Addendum No.: 003

Date Of Addendum: 6/25/2019

Energy Upgrades
Greater Bridgeport Community Mental Health Center
1635 Central Avenue
Bridgeport, CT
BI – MH – 111

1 MECHANICAL & ELECTRICAL PLAN GROUND FLOOR
SCALE: 1/8" = 1'-0"

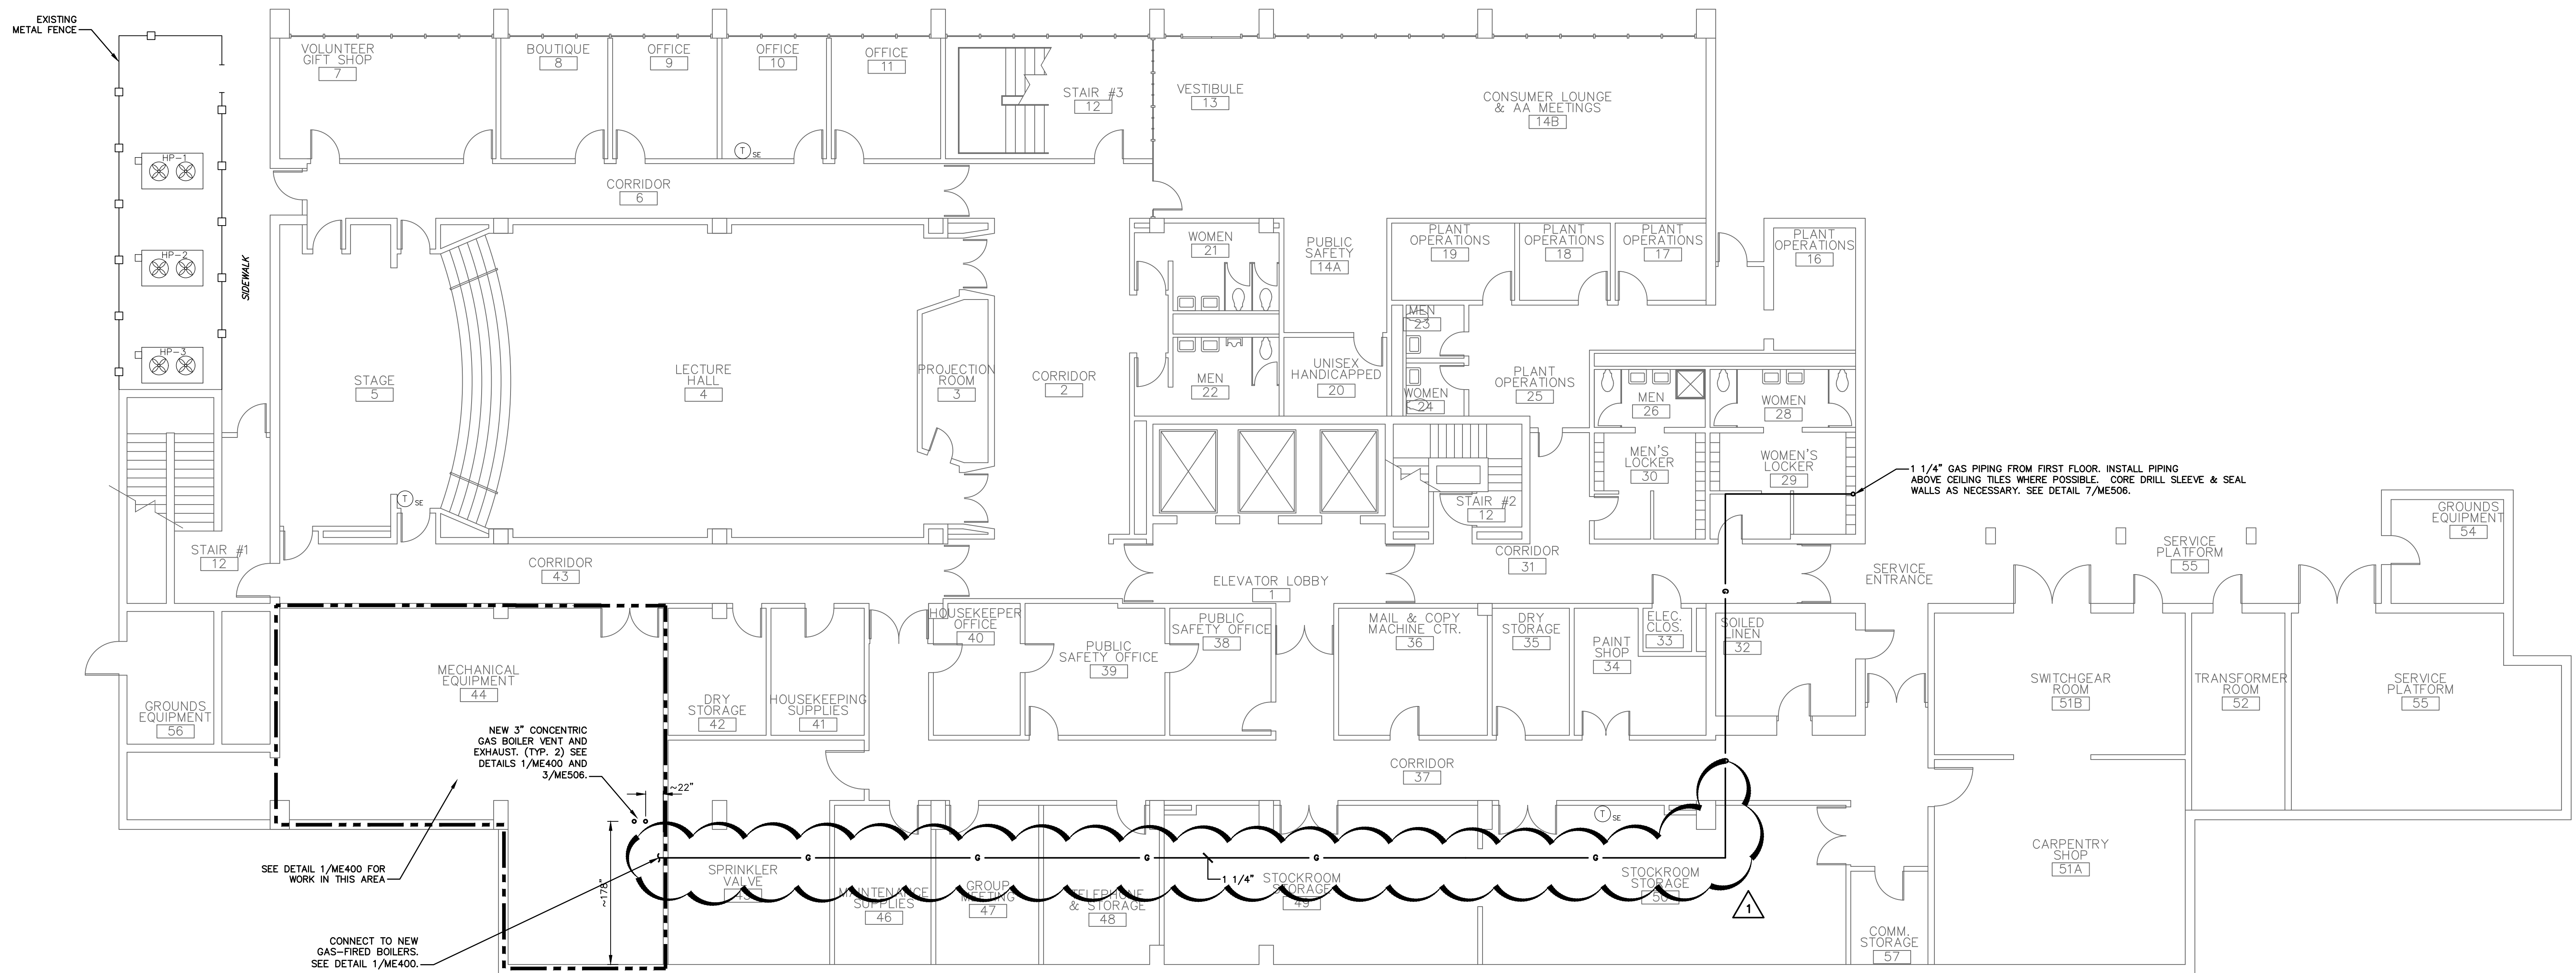
The gas line in the basement will be relocated to penetrate through the walls as shown in the attached drawing, ME100 Revision 1.
